Re: FirstLight Hydro Generating Company, Turners Falls Hydroelectric Project (FERC No. 1889) and Northfield Mountain Pumped Storage Project (FERC No. 2485).
Additional Proposed Study- Barrier Net Assessment

Re: **Responses to Stakeholder Comments on Barrier Net Study Plan for the Northfield Mountain Pumped Storage Project (FERC No. 2485)**

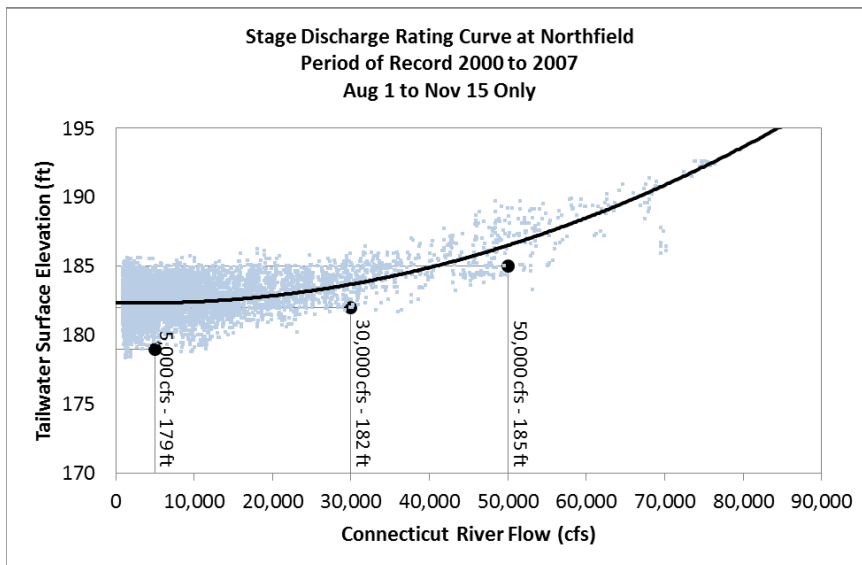
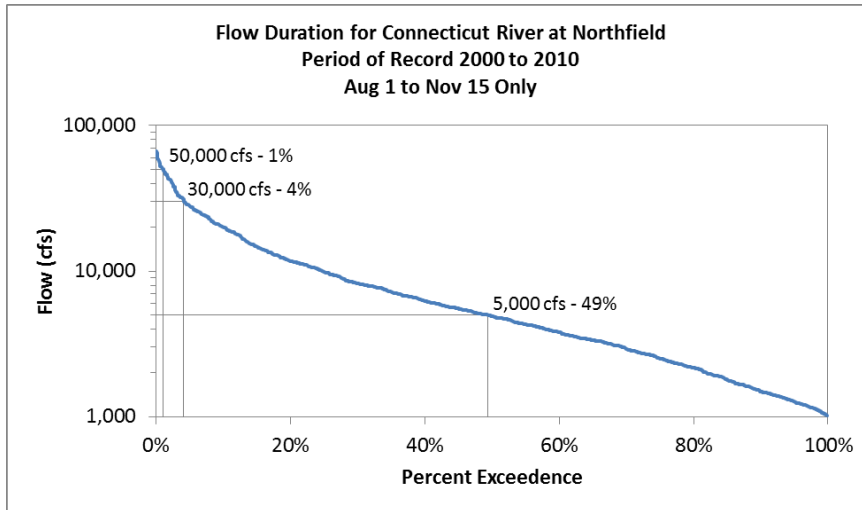
Comment: Regarding 4.0 Update CFD Modeling. The proposed Net Study, describes the selected river test flows of low (5,000 CFS), medium (30,000 CFS), and high (50,000) CFS. We recommend natural flow conditions for the period from August 1 to November 15 be used to establish the low, medium and high river discharge values for use in the model to better represent the conditions during the eel migration period in question. This period includes the lowest flow months. The occurrence of river flow events as high as 30,000 or 50,000 CFS in the expected operational period of the net are both uncommon in frequency and brief in duration.

Response: Shown below is the flood frequency analysis and stage discharge rating curve for flows between Aug 1 and Nov 15. The low, medium, and high flows correspond with 51%, 96%, and 99% exceedance. The previous CFD analysis predicted that maximum drag forces occurred during the low flow. It would be informative to simulate a lower flow case (less than 5,000 cfs) to determine the velocities and drag forces. The previous CFD analysis predicted that maximum shear forces occurred during the 50,000 cfs flow. It may be valuable to simulate the same high flow case with updated drag coefficients to calculate the shear force on the barrier net. The CFD analysis can be simulated at additional flow conditions, as desired.

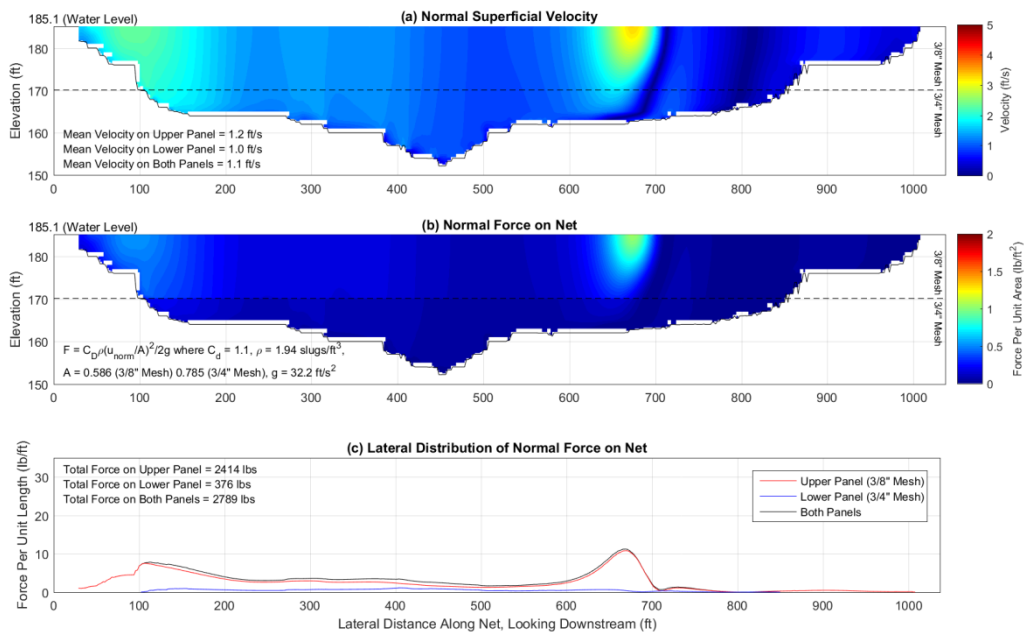
A better description of deliverables is needed. How will the CFD model results be presented? How will the outputs of MATLAB be presented? See comments on Section 1.0. Stakeholders will need reassurance that we will get enough information to determine if the net is likely to work and not create other problems.

- Summary of forces acting on the net in tabular and graphical form. Example figure showing lateral distribution of forces is shown below:
